Information Request 14

Responses to Information Request 14

IR 14 –Tailings Storage Facility Seepage - Mitigation

FIGURE 14B-1
TSF SEEPAGE FLOW CHART FOR END OF YEAR
OPERATIONS (YEAR 17)

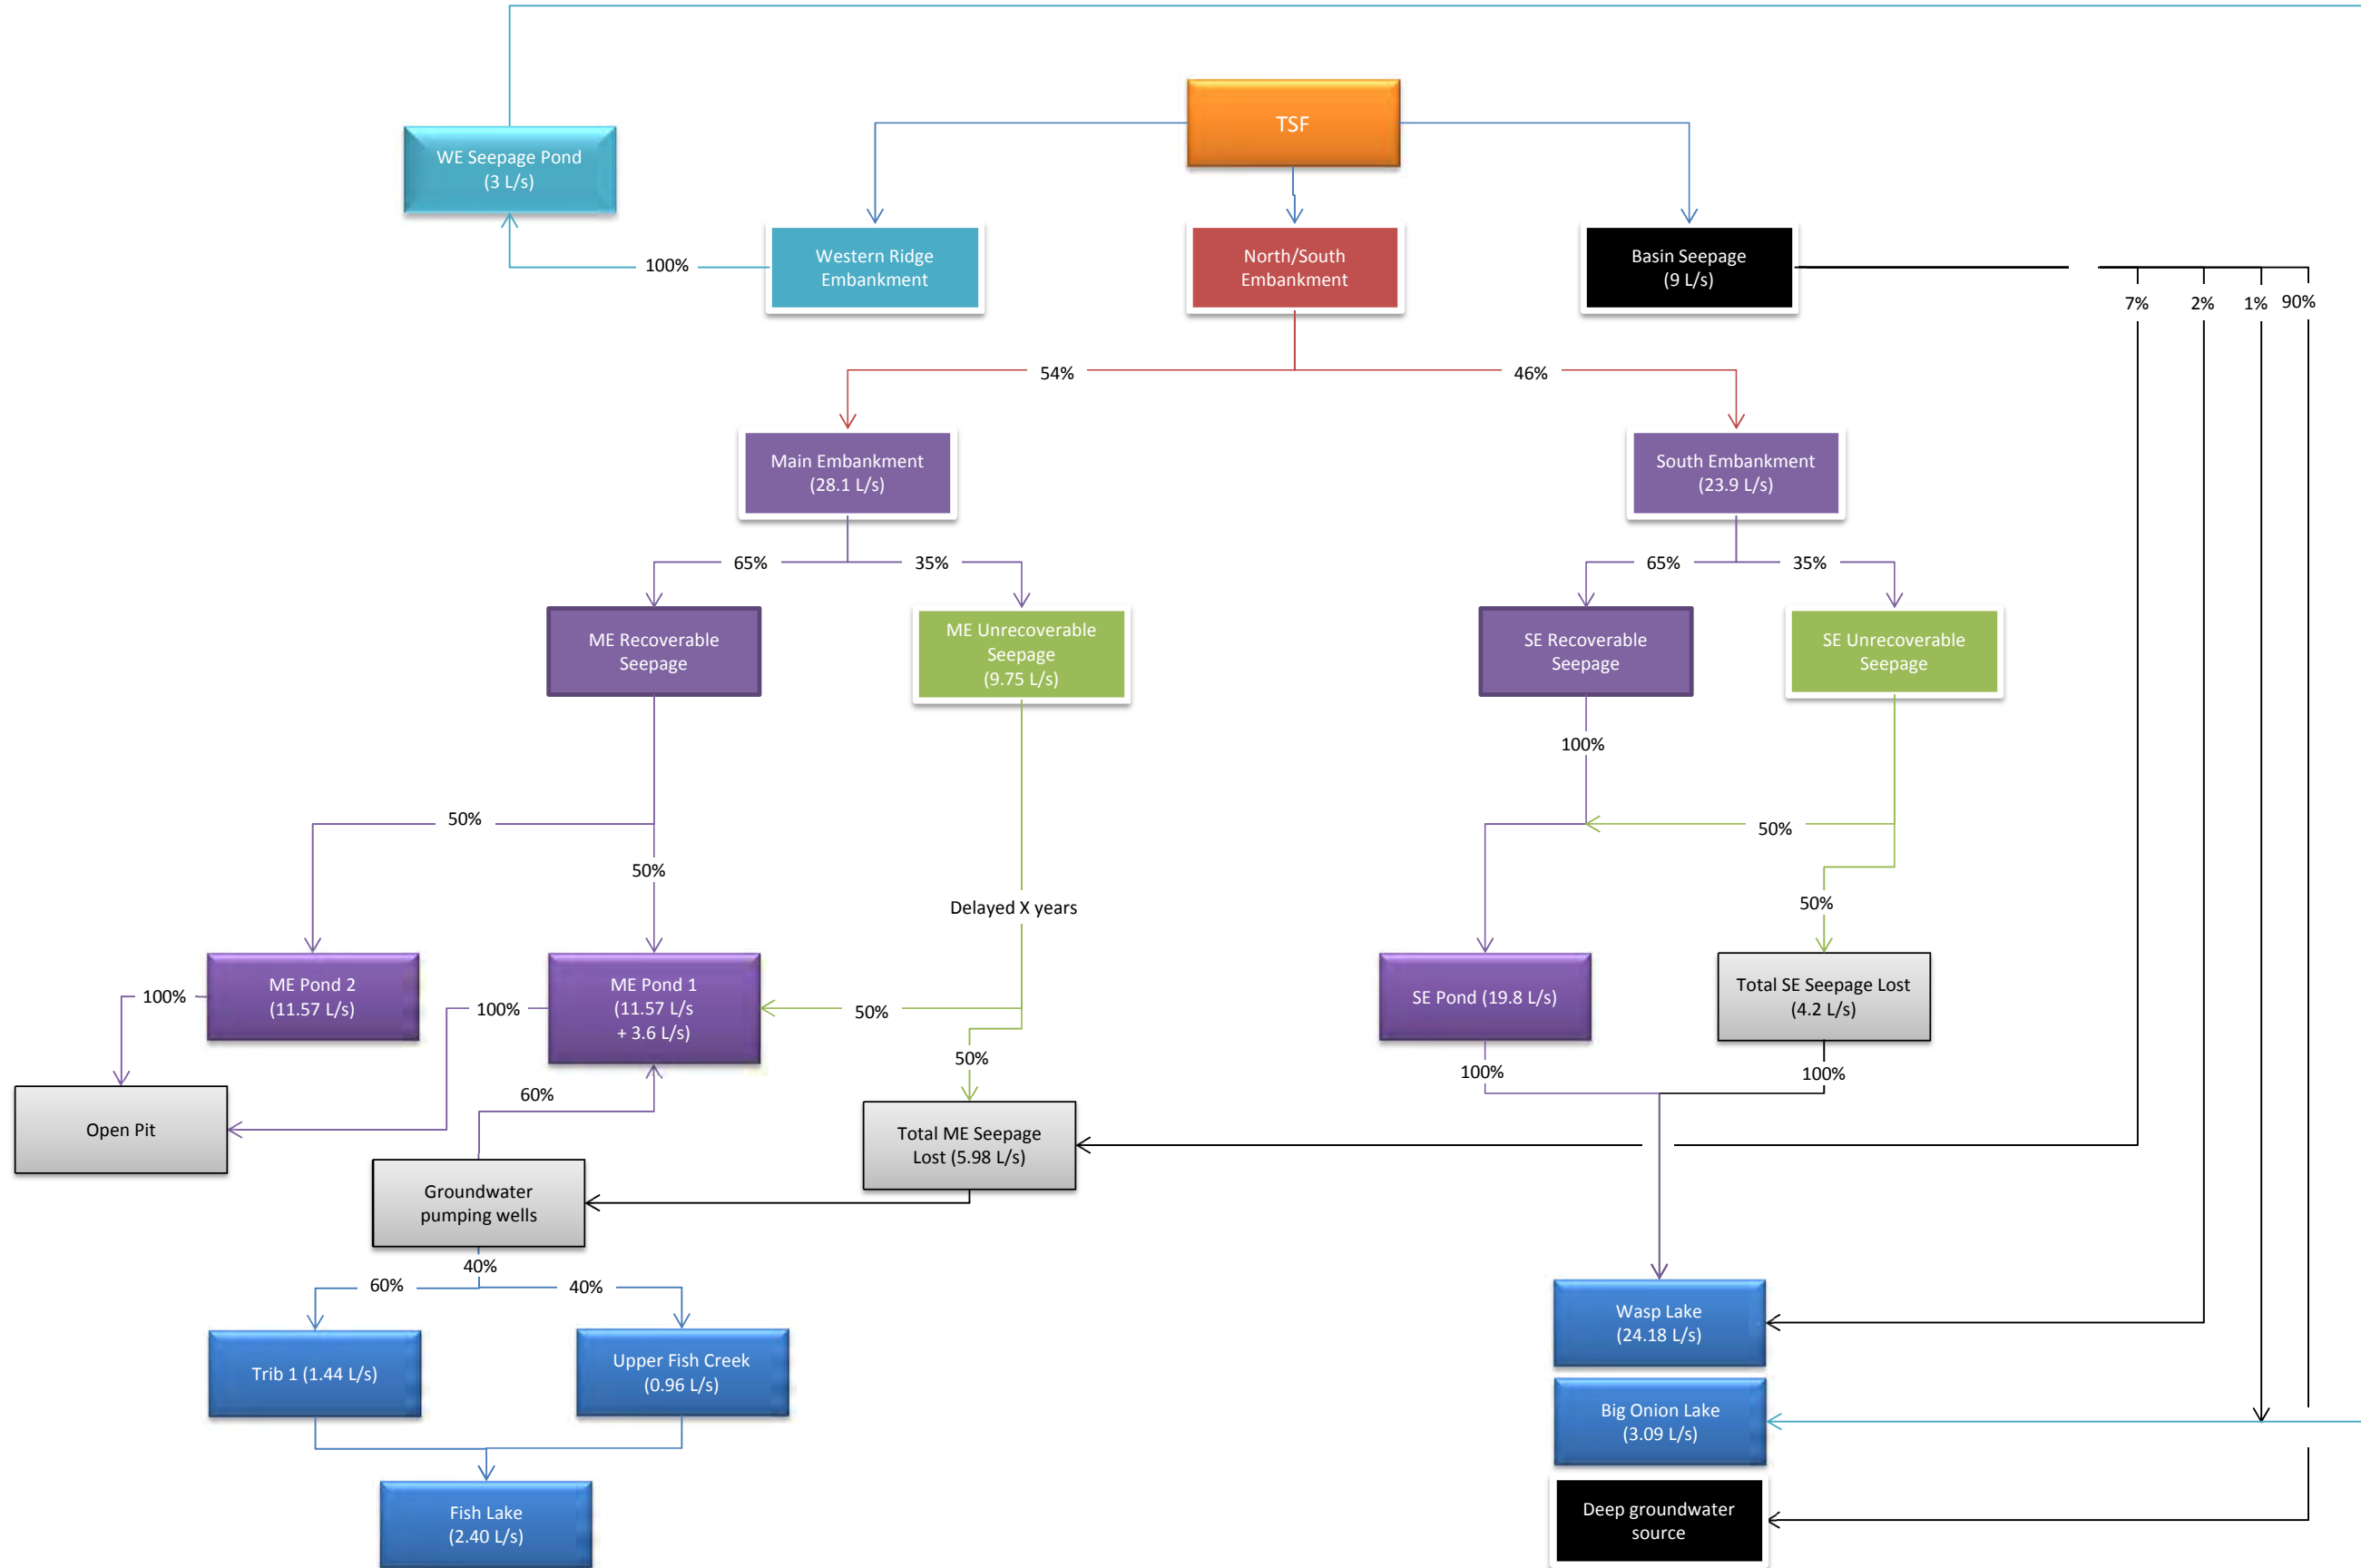
Provide evidence through further analysis to support estimates of TSF seepage recovery efficiencies for the various mitigation measures that are proposed to protect water quality in Fish Lake.

The 2D Seepage Model (EIS Appendix 2.2.4-D, Ref: VA101-266/27-3, Appendix B) presented the estimates of seepage from the TSF at the scale of the embankments. Figure 2.7.2.4A-10 from the EIS, reproduced here as Figure 14B-1 shows the estimated percentages for all the seepage flow paths, which were inputs to the water balance, and ultimately the water quality model for assessing water quality changes for Fish Lake and the greater receiving environment.

The basis for the estimate of seepage being directed through the embankment and recovered (65%) versus that which is assumed to not be captured immediately by the embankment filters (35%) is derived from the 2D Seepage Model listed above. While this model identified the need to install depressurization wells as part of the TSF design, the depressurization wells were not specifically a part of the seepage model results. Hence, there is a level of conservatism built into the basis for 65% flow through the embankment, as it would only increase with inclusion of the depressurization wells. In other words, greater flow of seepage will be directed through the

The basis for the estimate of the total 35% flow that will be captured by the seepage collection ponds (50%) and that which will bypass the ponds (50%) relates the expected flow paths within the various materials in the foundation and downstream of the embankment, as well as additional project experience relating to seepage recovery from tailings facilities. Optimization of the seepage recovery ponds will occur during the detailed design phase of the project, which could lead to greater recovery of that seepage presently assumed to bypass the seepage collection ponds.
